QUALITY ASSURANCE -- NON-CONFORMANCE REPORT

Report No: NCR-000511

Reference Description: OBG 6AW Floorbeam FB019-001 does not meet the flatness requirement

Job Name: SAS Superstructure

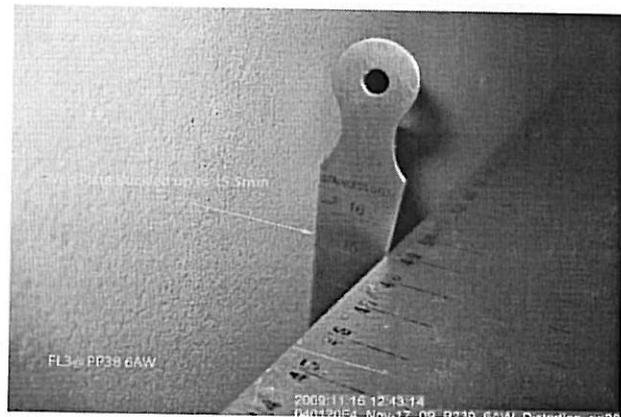
During random visual inspection of OBG Segment 6AW at panel point 38, this QA Inspector observed the following distortion. The FL3 floor beam FB019-001 web plate designated as X19A was found distorted up to 15.5mm over 1000mm. The measurement was taken about 900mm below the upper flange plate.

AASHTO 11.4.13.2 Flatness of Panels: "The maximum deviation from detailed flatness or curvature of a panel shall not exceed the greater of 5mm or $D/(144 \cdot vT)$."
